Access Compliance Report

Public Rights-of-Way

(Curb Ramps)

Intersection ID: N/A	Main Street: DELUCA_DR	Cross Street: HAMEL_ST	Location: NW
ADA ID: F6D8ED83BF61	Ramp Type: Combination2Diag	Initial Pass/Fail: Fail	Overall Compliance: No
		Severity Score: 0

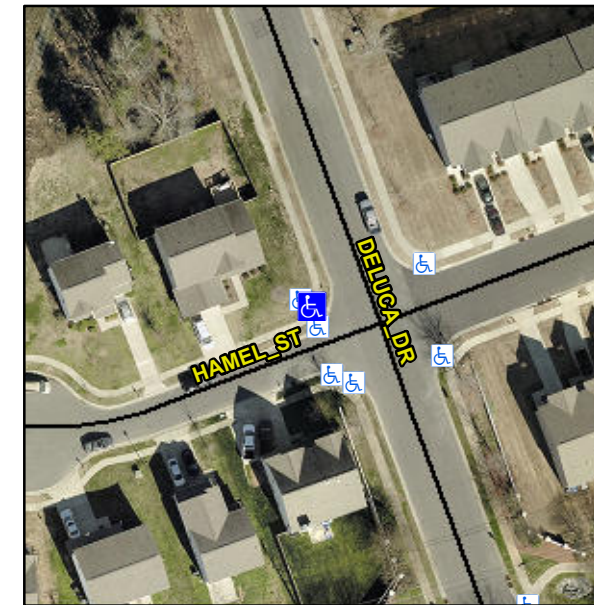
Not Found, R304.5.1, R304.5.1, R304.5.3

Compliance	Description	Data	Compliance	Description	Data
N/A	Ramp Length LT (in)	29.5	N/A	Ramp Length RT (in)	22.0
No	Ramp Width LT (in)	47.5	No	Ramp Width RT (in)	47.0
Yes	Ramp Slope LT (%)	7.2	Yes	Ramp Slope RT (%)	3.2
No	Ramp XSlope LT (%)	2.5	Yes	Ramp XSlope RT (%)	0.7
N/A	Ramp Length (in)	47.0	Yes	Ramp Slope (%)	3.0
No	Ramp Width (in)	47.0	No	Ramp XSlope (%)	3.3
N/A	Flare Type LT	N/A	N/A	Flare Type RT	N/A
N/A	Flare Slope LT (%)	N/A	N/A	Flare Slope RT (%)	N/A
N/A	Flare Traversable LT?	N/A	N/A	Flare Traversable RT?	N/A
N/A	Landing Length (in)	N/A	N/A	DWS Provided?	N/A
N/A	Landing Width (in)	N/A	N/A	DWS Contrast?	N/A
N/A	Landing Slope (%)	N/A	N/A	DWS Length (in)	N/A
N/A	Landing X Slope (%)	N/A	N/A	DWS Full Width?	N/A
N/A	Landing Curb? (Y/N)	N/A	N/A	DWS Offset (in)	N/A
N/A	Shared Landing?	N/A			
N/A	Gutter Ponding?	N/A	N/A	Gutter Slope (%)	N/A
N/A	Gutter Lip Ht (in)	N/A	N/A	Gutter X Slope (%)	N/A
N/A	Painted X Walk1?	No	N/A	Painted X Walk2?	No

Remove & Replace Curb Ramp With Two New Directional Ramps or Equivalent.
